SURVEY PLAT FOR
PROPERTY SPLIT
PT. SW QUARTER, SECTION 15, T-22, R-19 JACKSON TOWNSHIP, RICHLAND COUNTY, OHIO
DATE: OCTOBER 21, 2024 SCALE: 1"=100'
TAYLORTOWN_RD_2856

## Lot Split Application

# HEALTH DEPT. MAP

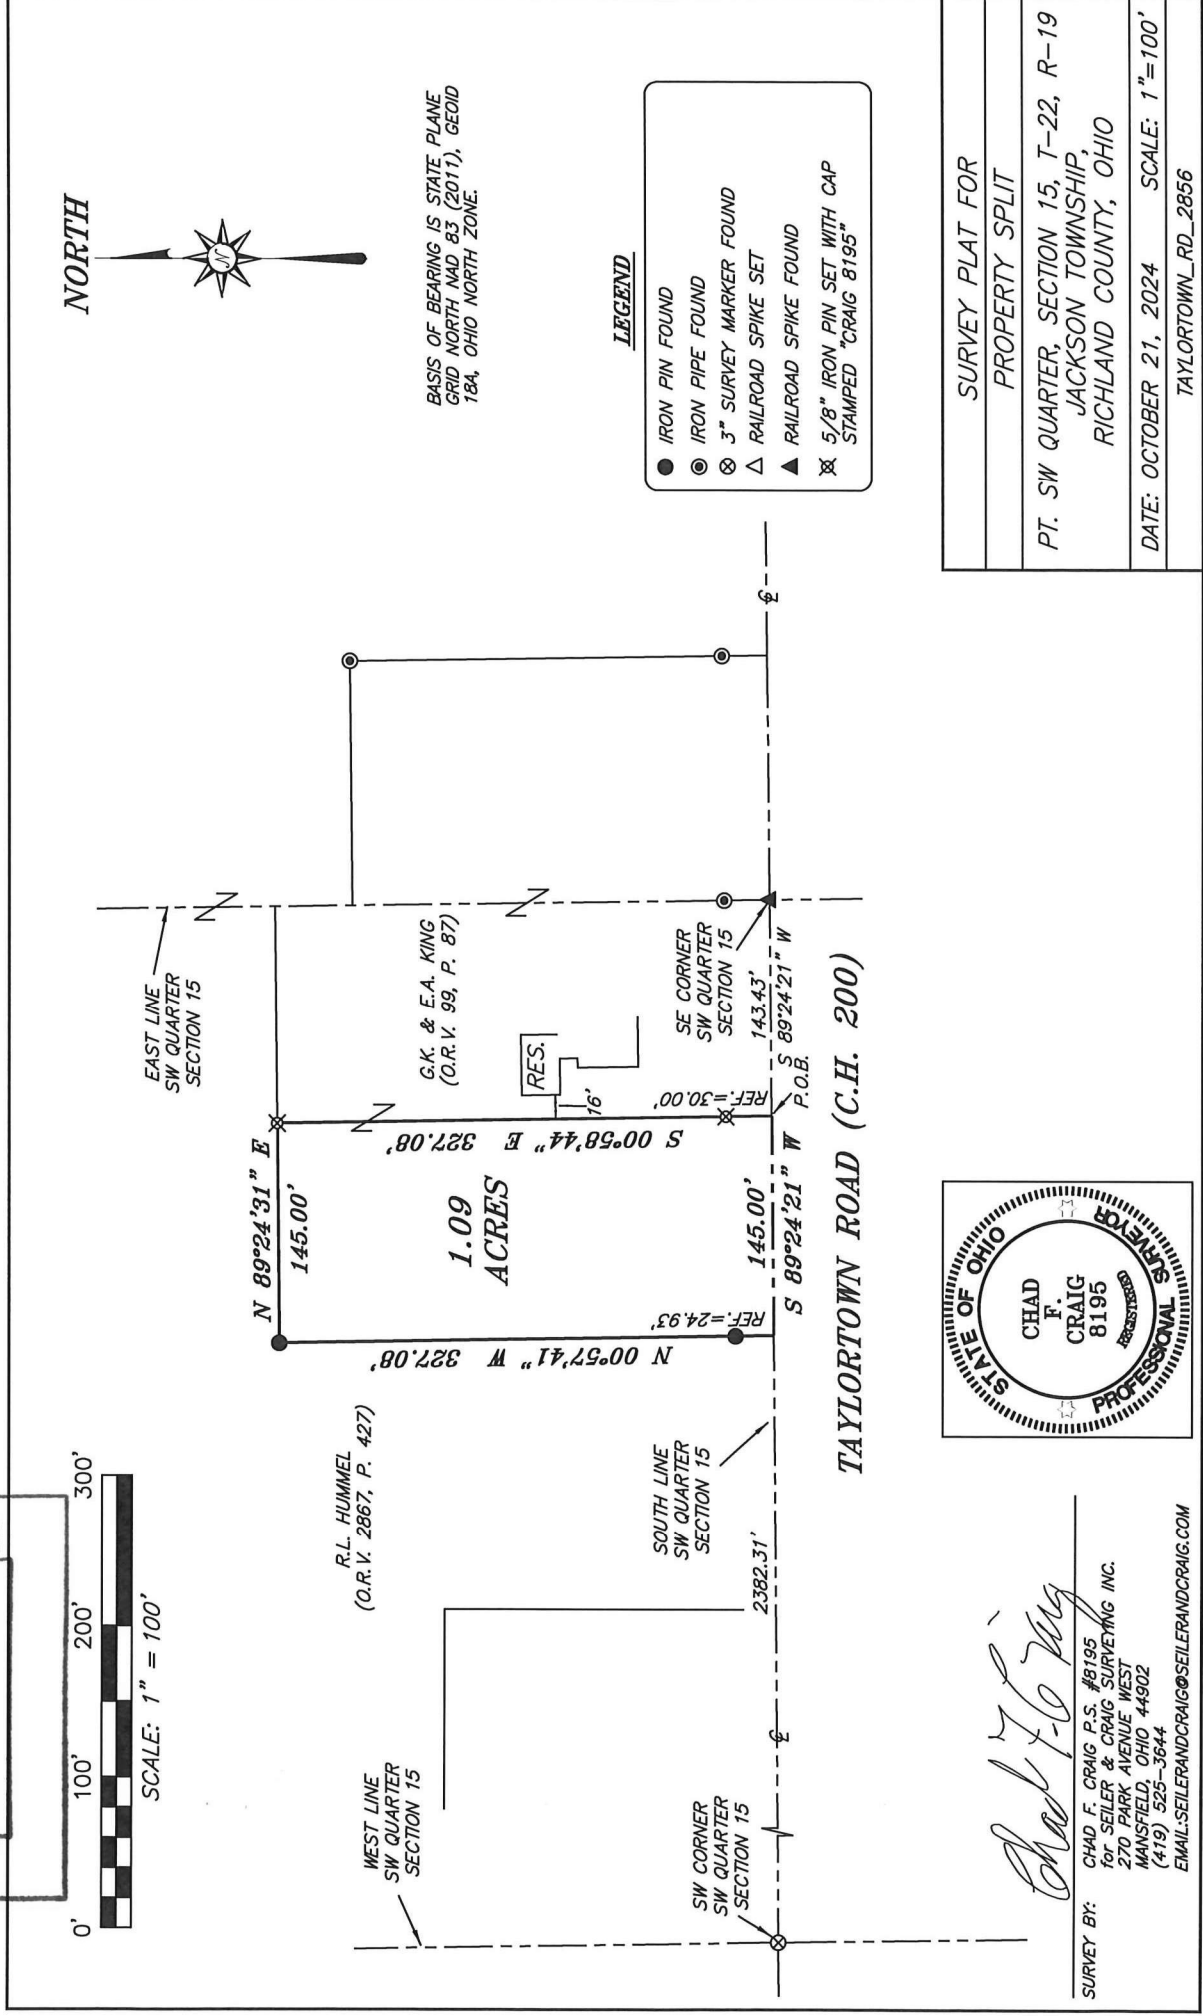
Information provided with this lot split application did not include or indicate any potential or existing easements or utility easements.

Areas designated for installation and/or replacement of a sewage treatment system shall be undisturbed and protected from damage or disturbance. OAC 3701-29-15(P)(1)
